Sierra Ranches Wetland Preserve

Davie, Broward County, Florida, USA

What's the Problem?

Original planting plan. Some substitutions have been approved that are not reflected in this plan.

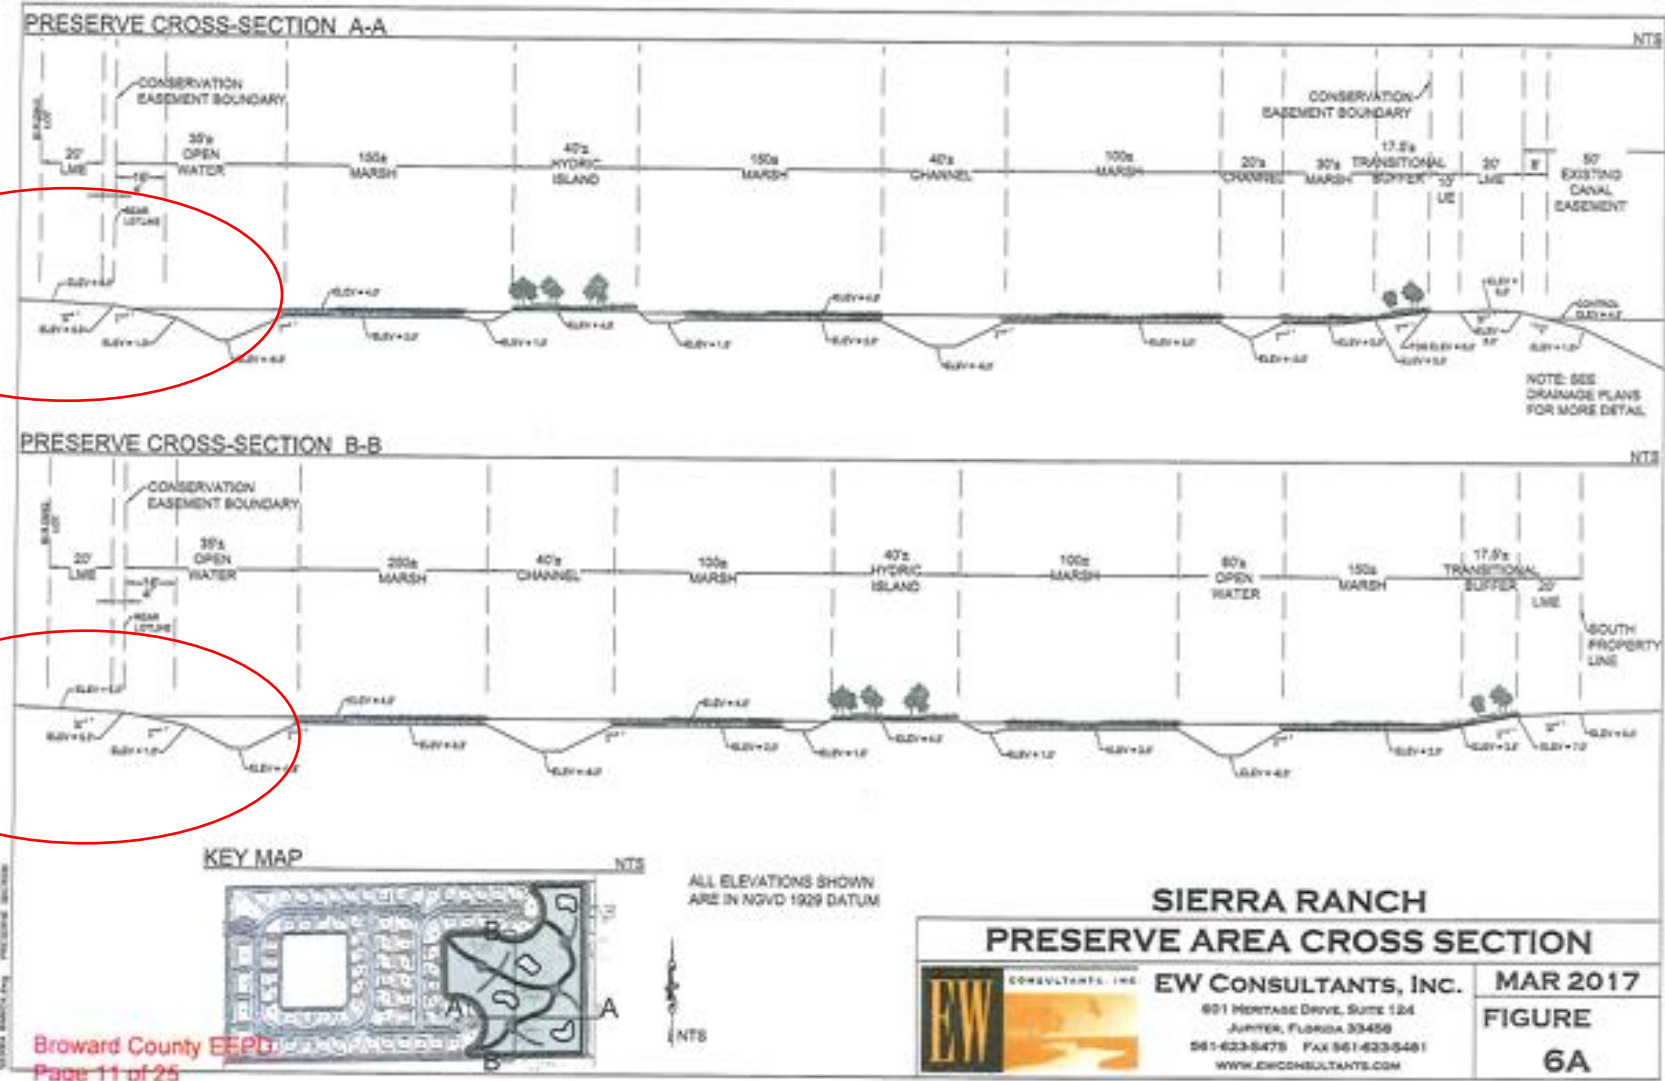
This will get redesigned once the open water channels around residential lots are brought to CBWCD depth code and redesigned for long-term engineering stability

Regulated Depth vs. Design Depth vs. Actual Sep '23 Depth

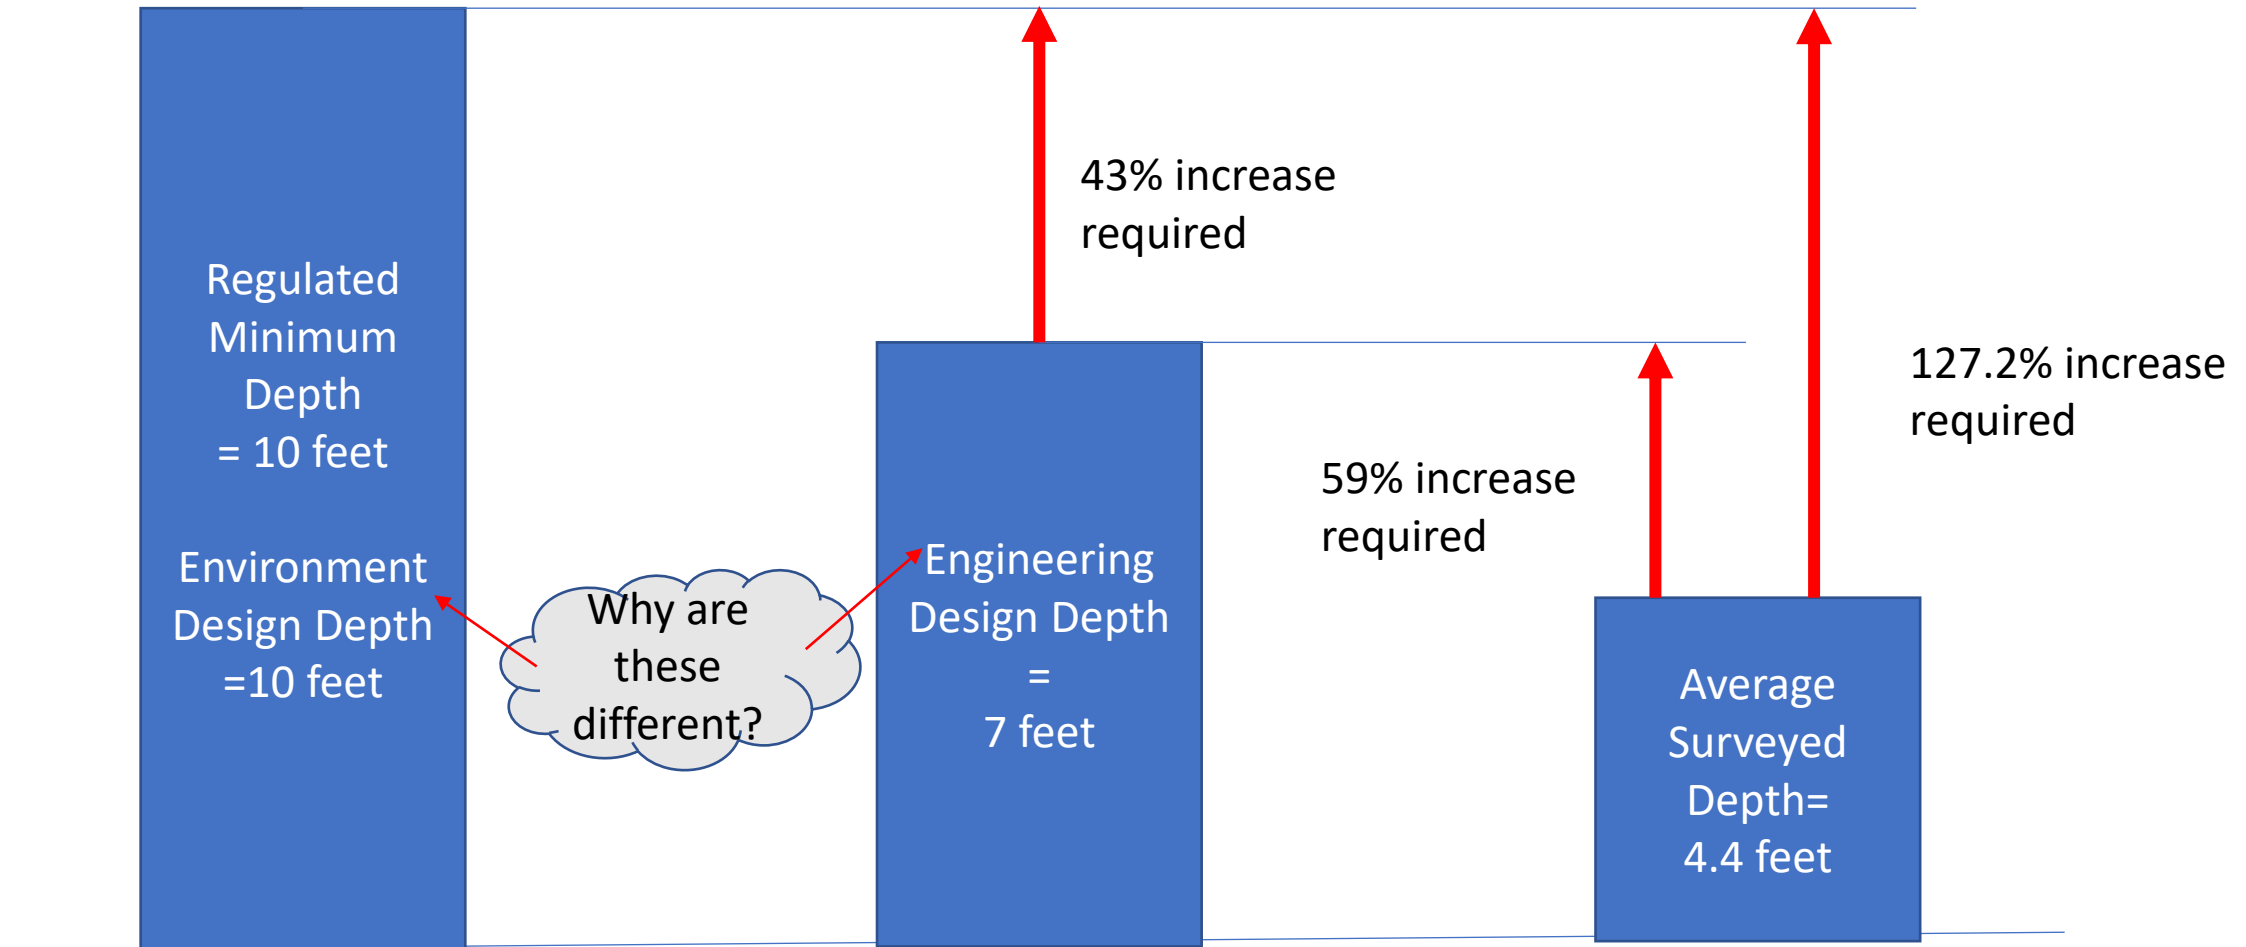
- The problem is that the water channels around residential lots is not designed to regulated minimum depths (10 feet) for excavations required by the design standards of Central Broward Water Control Board, the political special district, that has jurisdiction over this stormwater flowage, drainage and retention body

- These depth standards supersede any “flawed” permit that may be been issued on the project. In fact the permit contains conflicting information- the environment portion of the project shows a depth of 10 feet and the engineering portion of the permit (which was signed only in September 2023 way after construction date) shows a depth of 7 feet against regulation.

- The consequences of these sub-optimal design choices and poor engineering have manifested in a catastrophic failure of water channels around residential lots as confirmed by measurements taken just two years after build

- Average depth reduction of 37% and as much as 48% at the most catastrophic failure section
 - This has led to nuisance native and non-native wetland species proliferating through the open water channels around residential lots. They have not also been controlled via maintenance activities.

- The amount of dirt in the water channels due to slouging and post-construction defects is estimated to be enough to fill an almost 4 foot 9 inch diameter pipe 2190 linear feet long with dirt. That's a LOT!!!

2018 Executed Environmental Plan showing 10 feet depth. CBWCD rules on grading will prevent this depth from being achieved if the Open water is artificially limited to 35 feet

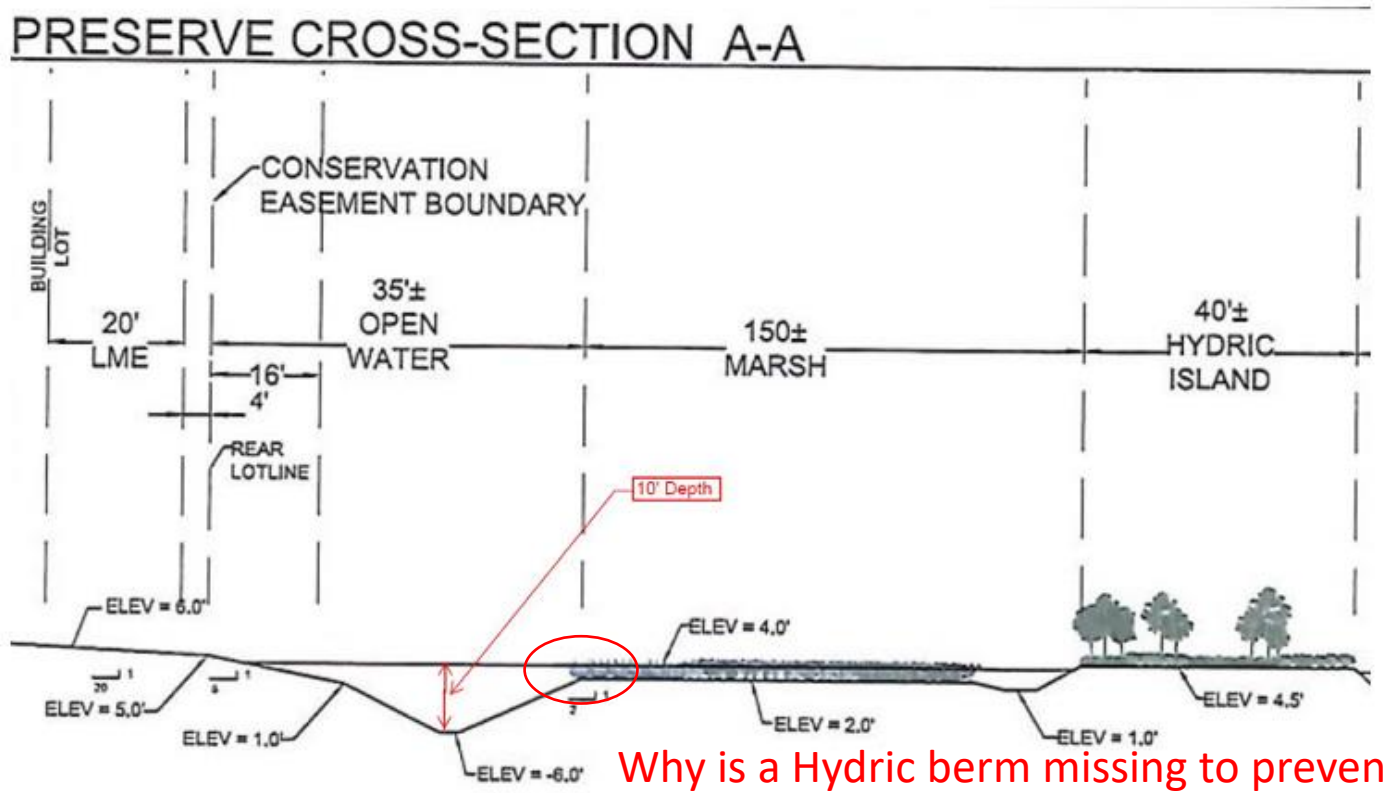
Why is a Hydric berm missing to prevent sloughing of open marsh muck into the open water flow channel?

Current Cross-Section from Wetland design plans (showing 10' Channel)

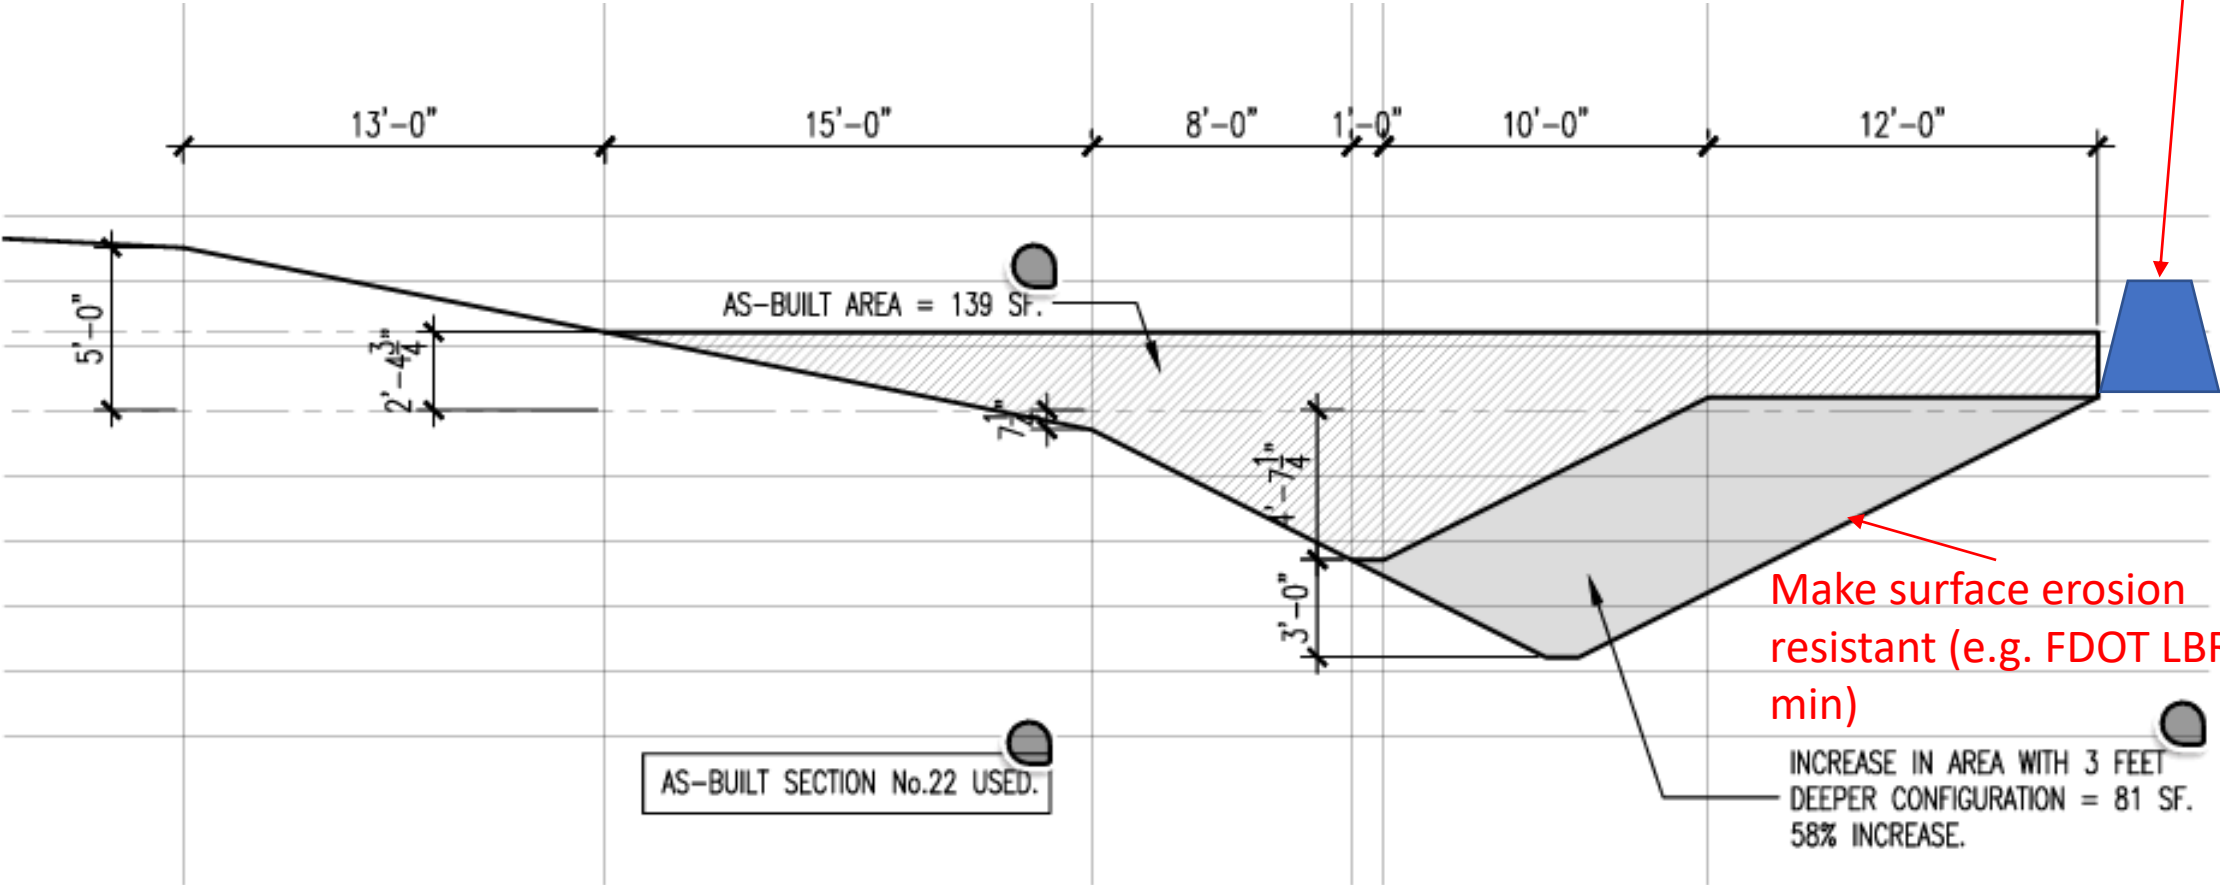
Impact of making channel deeper by 3 feet i.e. total 10 feet deep and maintaining V-section

INCREASE IN AREA WITH 3 FEET DEEPER CONFIGURATION = 81 SF. 58% INCREASE.

Add hydric berm to prevent sloughing of muck from marsh into the water channel

Make surface erosion resistant (e.g. FDOT LBR 40 min)

The Curious case of Lot #20

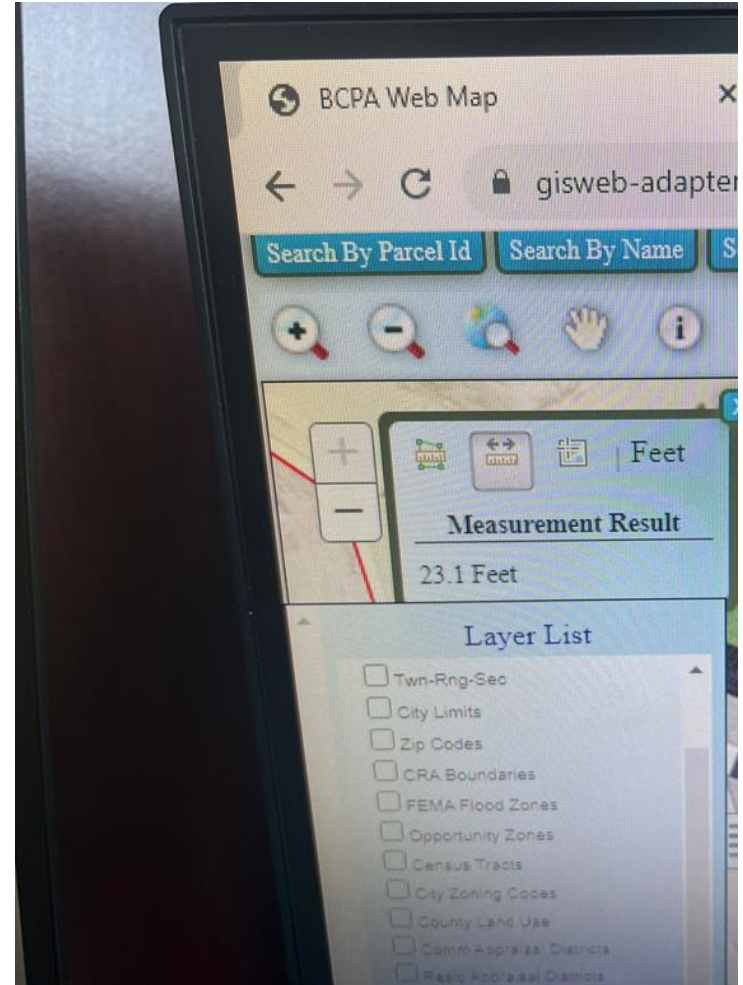
Satellite Image apparently suggests 23 feet open water channel width which is over 10 feet shorter span of open water vs the as builts that show 34 feet the same year (how is that possible?)

Shallow marsh portion is identified with dark shade in satellite image of water

The Curious case of Lot #20

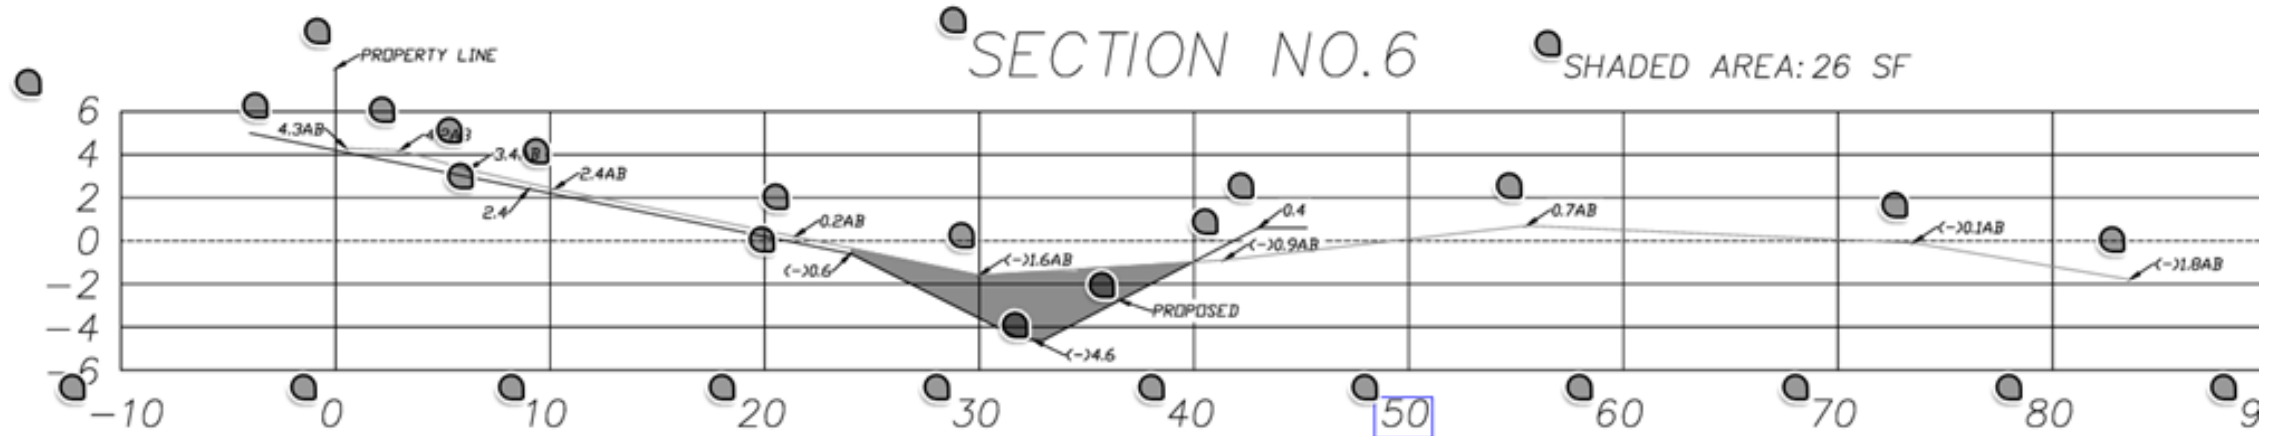
Data from September 2023 shows the deepest point is 4 feet vs. 7 feet, an almost 43% decrease
